5	Consultant	Wahib Medanat Consultant Engineer	Rep No.	12-09052022
	Contractor	Derar Saraireh & Sons for Engineering & Contracting	Tender No.	(11/2019/USAID/SKEP/3/S) Schools for a Knowledge Economy Project (SKEP) - Phase (3) Package (1, 2)
	Site Name	Al Khansa' Basic Mixed School- Al Balqa	Day/ Date	Mon. 09/05/2022
	Duration of Project	450 Calendar Days	Total Project Budget	9,789,417.840 JD

SKEP III Home Office Support Site Visit Report

(Figure: 15 & 16)

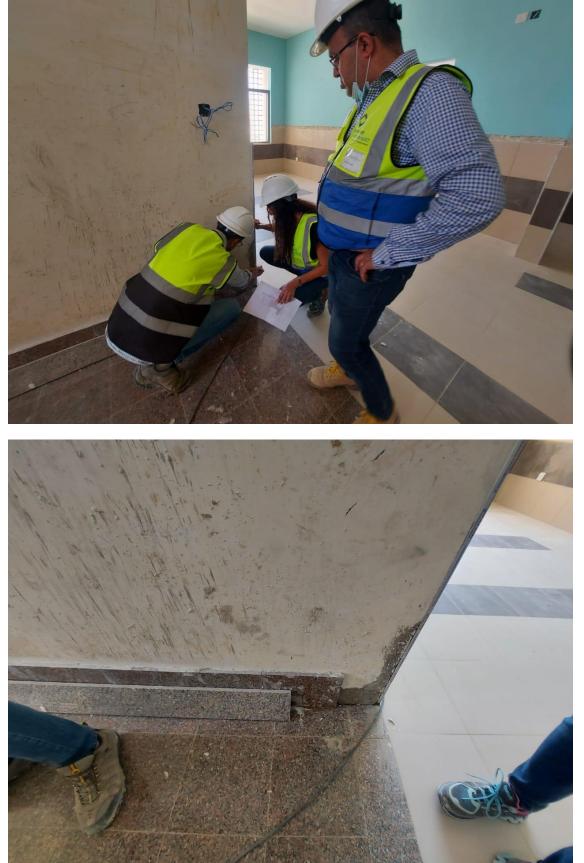
The team inspected the executed granite coping at the window jamb (see point no.3 above) and observed a contradiction with the approved sample regarding the prominence of the granite piece. The Contractor was requested to rectify

(Figure: 22, 23, 24, 25, 26 & 27)

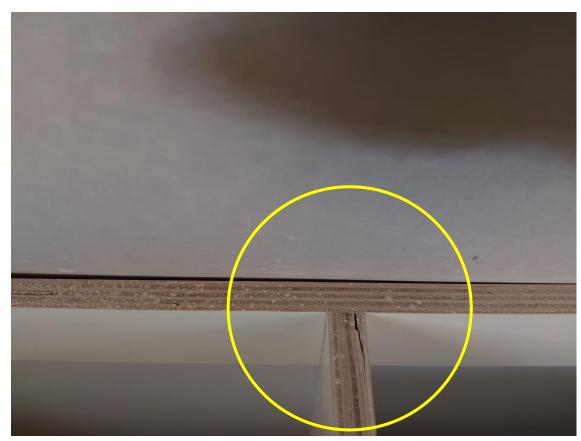
The team observed defects in the delivered cabinets for the (KG) and requested the Contractor to rectify. The defects include the laminated partitions, unvertical ironmongery handles and defects in beech wood sections.
